████████████████████ I am writing to object to the planning application for the house next door, 75 Lawn Road (Planning reference [2018/3428/P](#)).

The submitted planning application for 75 Lawn Road conflicts with a number of published planning and conservation policies and guidances, including Camden's Local Plan 2017, Camden's supplementary planning guidance CPG 1- Design and CPG 5 – Amenity, and the Parkhill and Upper Park Conservation Area Appraisal and Management Strategy.

**Figure 1: Proposed rebuilt rear as shown in an excerpt from the applicants' submissions for Application 1 (2017/6726/P) Right of Light Consulting's 3D model.**

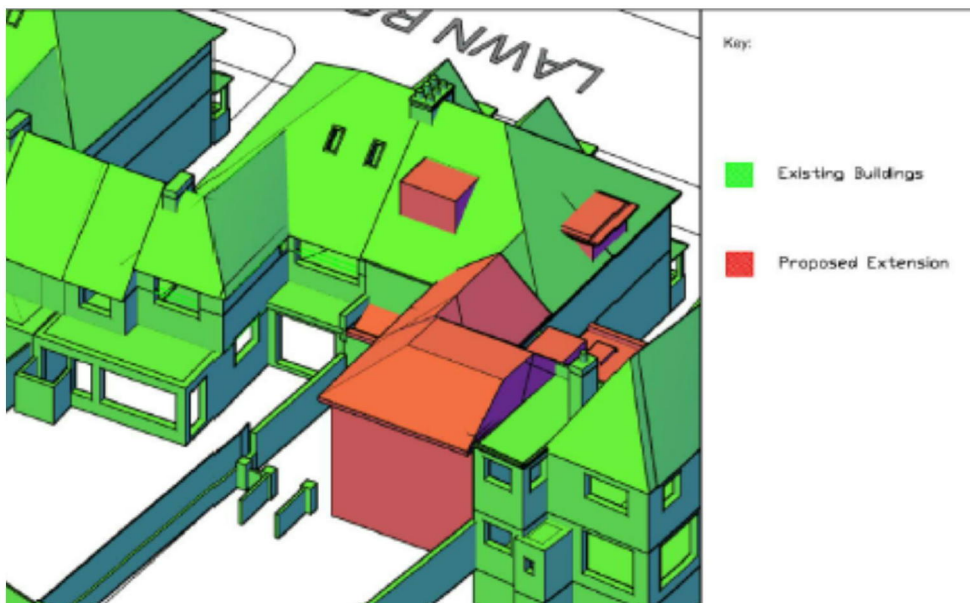
Changing the colour to white makes no difference to the dimensions of the 2-storey extension and does not change the bulk, scale, and mass of the extension, including its greatly expanded pitched roof. It is clearly still not

subordinate and not secondary to the existing, original house – indeed the original shape and roofline of the rear of the house will completely disappear.

Building onto the existing rear outrigger at 1<sup>st</sup> floor and roof level creates a cumulative massing that ruins the existing rear balance and symmetry between the paired 74 and 75 Lawn Rd. It also creates a sense of overbearing, loss of outlook and sense of enclosure for the paired house, 74 Lawn Rd.

The 2-storey rear extension will be incongruously large and obtrusive – it is totally out of scale with the existing original house. The development's size will be out of character for the rear of these 1920s Arts & Crafts style family homes.

The proposed new 2-storey rear extension at 75 Lawn Road will be around 6.4 metres wide, more than double the existing width of the rear projection and with a far higher roofline. This scale of development is inappropriate.

A one-storey infill extension, as included in Application 2 (2018/2136/P), would avoid this issue.

Figure 2: annotated excerpt from submitted plans

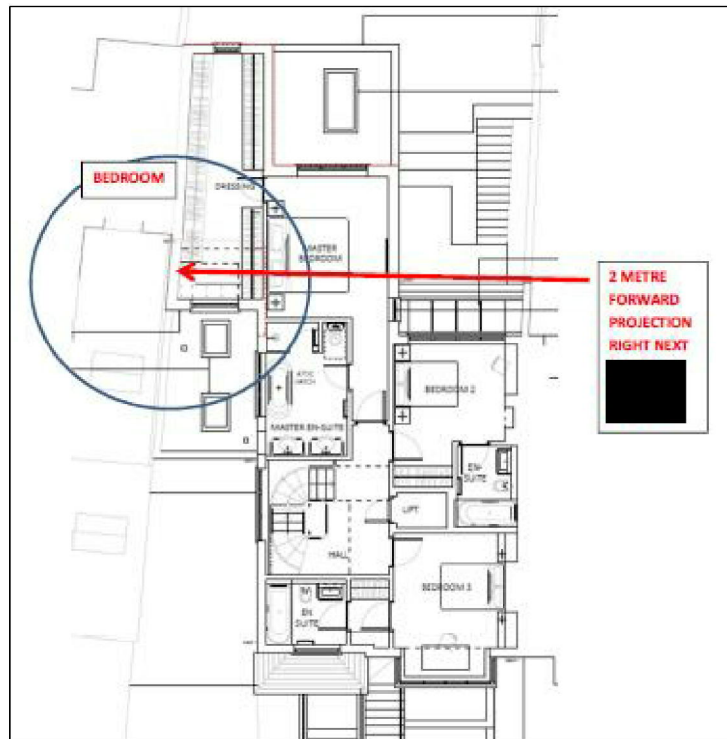
I object to the proposed 1<sup>st</sup> floor front projecting extension abutting my house. This extension will project forward by about 2 metres along the boundary wall [REDACTED] (see Figure 2).

**The room that is referred to in this comment is not a bathroom, it is a bedroom.** The fact it is dual aspect at the back is irrelevant to the way the proposed 1<sup>st</sup> floor extension at No. 75 will be over-bearing and create a sense of enclosure as I will be looking out through a tunnel effect that will 'box' me in. **It is not acceptable to**

allow a 2 metre projecting extension along a boundary right next to a bedroom window (see Figure 2). The edge of my window will be just 70 cm from the new 2 metre projection. It seems particularly unnecessary for No. 75 to have this front projection because that 1<sup>st</sup> floor room is shown on the application plans as a wardrobe/dressing room.
